OUR TOWN HALL

Alteration to height of Chimney 26

Justification Statement

Document reference: OTH-PUR-TH-RF-RPT-A-0230

A number of options of achieving the reduction in height were put to the client and the LPA design and conservation manager as the illustration fig 4 below.

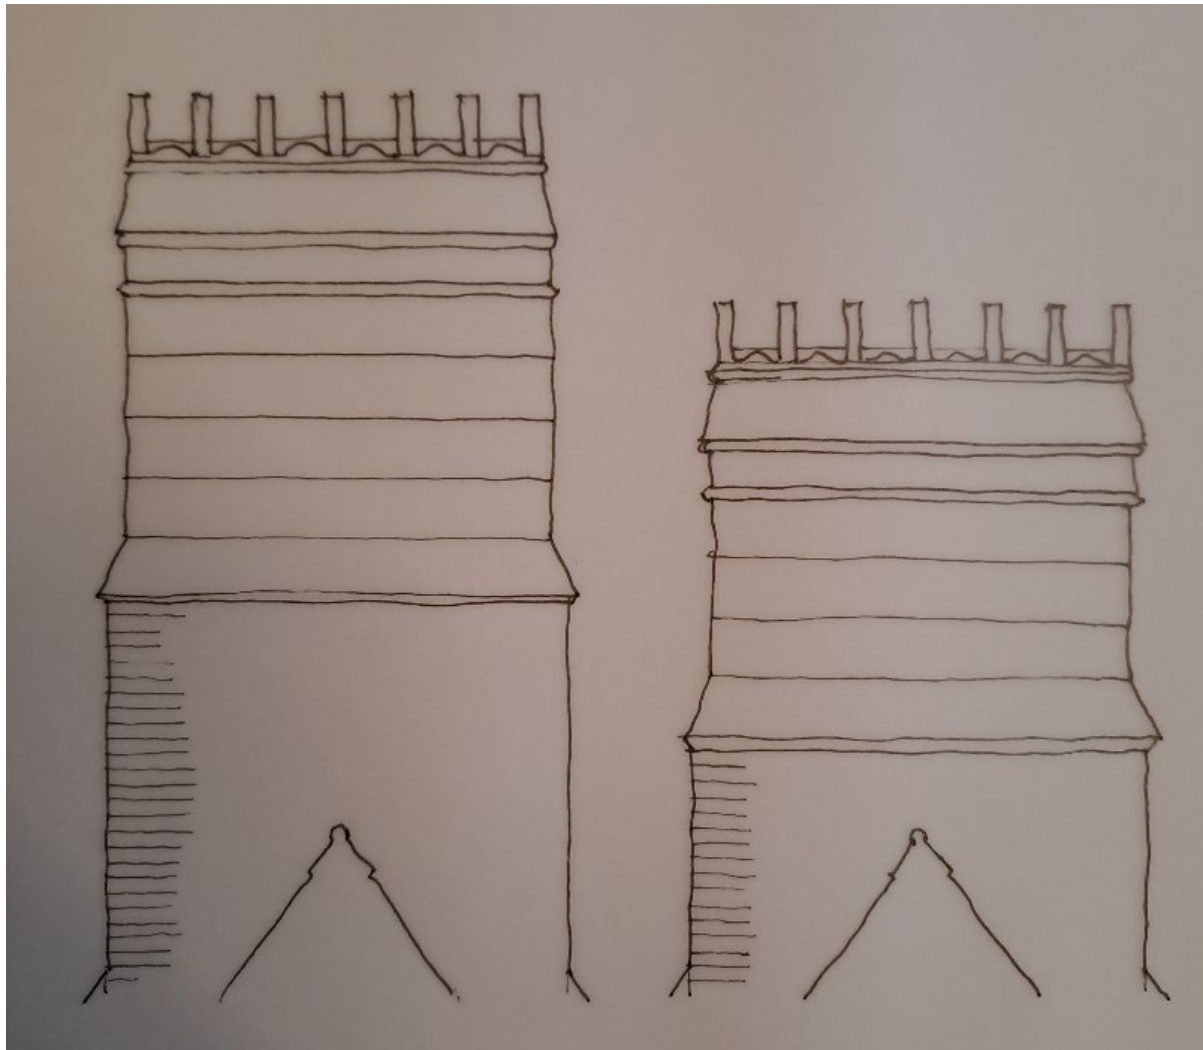
All the options proposed to reinstate all the moulded stone detailing to the cappings, string and plinth, as originally designed, and in consultation with the client and LPA there was a clear preference for option B which removed only one course of ashlar stonework and 10 courses of the brick below. This retained an appropriate proportion and spacing of features, and a practical distance above the ridge tiles of the Great Hall roof. The material arising from the alteration will be used for the repairs to this chimney of other features on the building within the project.

The sketch fig 5 below shows the comparison between the original design and the modified option B design

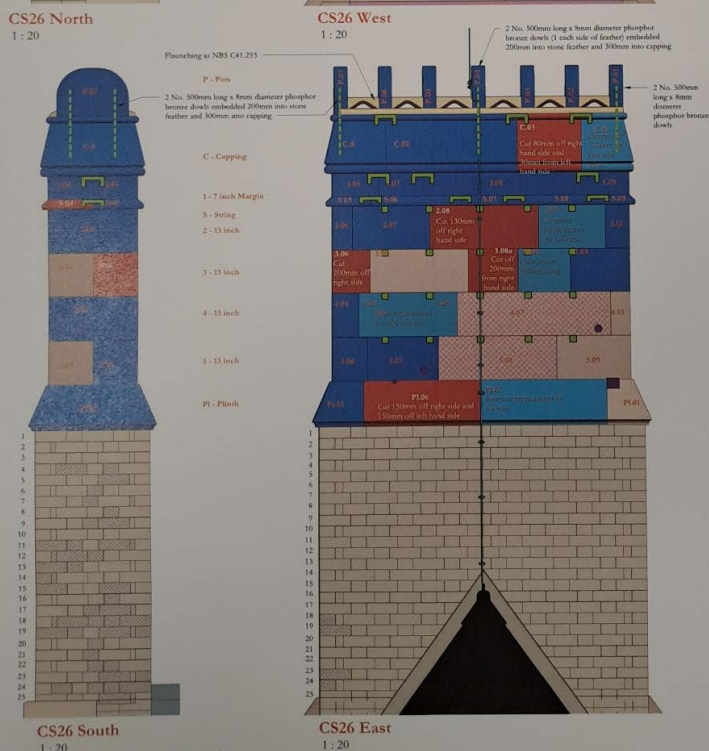
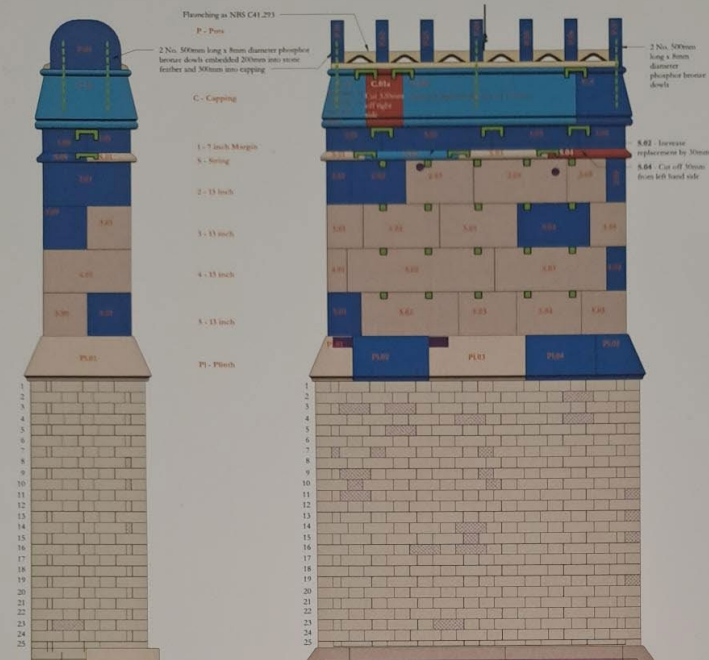
Original design on the left and modified design on the right.

The conclusion of this statement is that the modification of the design is minor and appropriate and the impact on the integrity of the original design is negligible compared to the significant mitigation of potential risk of damage to the historic fabric within the remaining construction stages and into the future.
